January 15, 2024

We are sending herewith the response to the EMB IVB EIARC comments, on the review and evaluation of our Environmental Performance Report and Management Plan (EPRMP) for our proposed OMCPC SMRA Diesel Power Plant Expansion. We would like to submit compliance to the additional requirements and the observed inadequacies in the documents, as follows:

**EIARC Comments on EPRMP**

**Figure 1.4. OMCPD SMRA Impact Area**

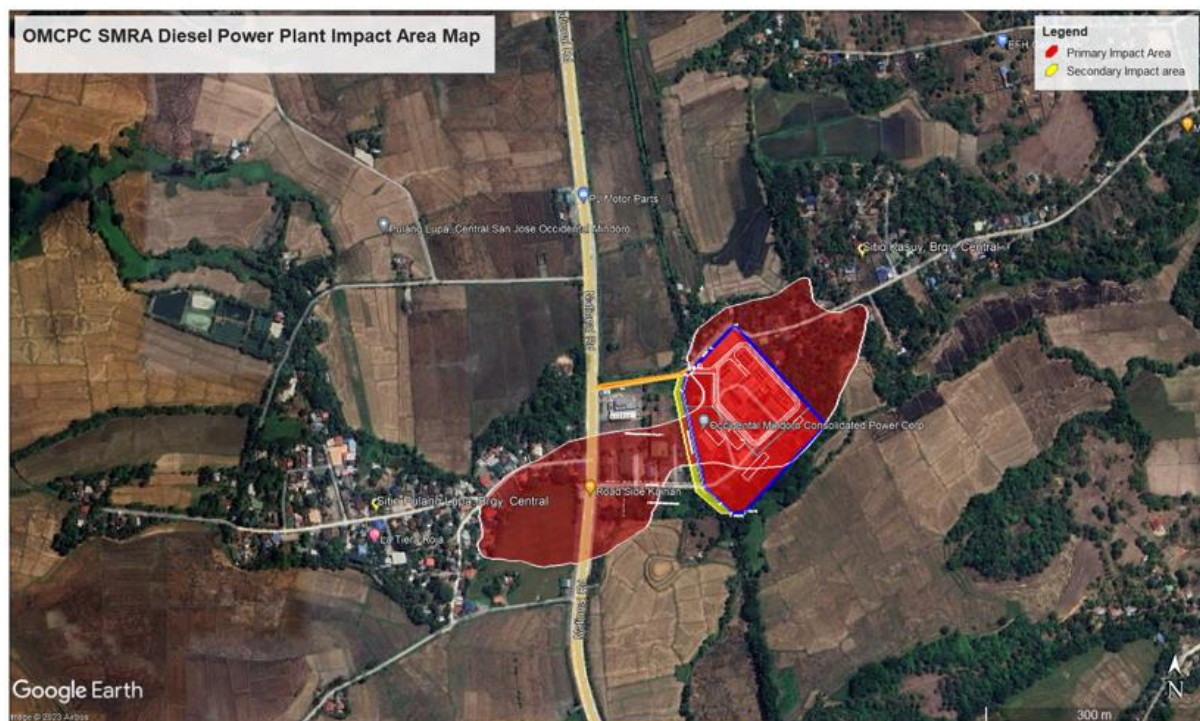
12. Section 10 of DAO 2017-15 cited that delineation of Direct Impact Area (DIA) shall be based on the project's impacts on air, water, land and people. Please expound the procedure of the relevant parameters used for the identification of the DIA.

13. Results of the air dispersion modelling should be incorporated in this chapter for the identification of impact area

Section 1.3.3 (Pages 1-5, 1-7 and 1-8) was revised as per comment to depict extent of impact area based on air dispersion modelling. The discussion on the impact delineation is shown in Page 1-8 in Chapter 1. Please see below screen shot of the revised Impact Area Map and the discussion as shown in Page 1-8:

The projected direct impact area from the gaseous emission of the combined operation of the existing powerplant and the additional powerhouse extends 260-meters northeast towards Sitio Kasuy, Brgy. Central and 360-meter southwest towards Sitio Pulang Lupa. The detailed extent of emission was determined upon the conduct of an air dispersion modelling for both the existing and the proposed expansion on the assumption that the stack heights of the gensets in the proposed additional powerhouse is 8 meters. For the existing and proposed emission sources (or a total of 9 gensets), the predicted dispersed concentrations of SO<sub>2</sub>, TSP, and CO were within the ambient guideline values set for these air pollutants while the predicted dispersed NO<sub>2</sub> was 1,832.6 µg/m<sup>3</sup>, which exceeded the ambient guideline value set for NO<sub>2</sub> at 150 µg/Nm<sup>3</sup>. At a stack height of 15 m, the highest predicted 24-hour average concentration of NO<sub>2</sub> (at the 98th percentile) of 151.3 µg/m<sup>3</sup> was slightly higher than the corresponding ambient guideline value. However, the dispersed ambient air concentrations outside the project boundaries were within ambient guideline value. OMCP will increase the stack height to ensure that it will meet the ambient guideline value for NO<sub>2</sub>.

Duly noted and incorporated as shown in the Impact Map in the preceding page.
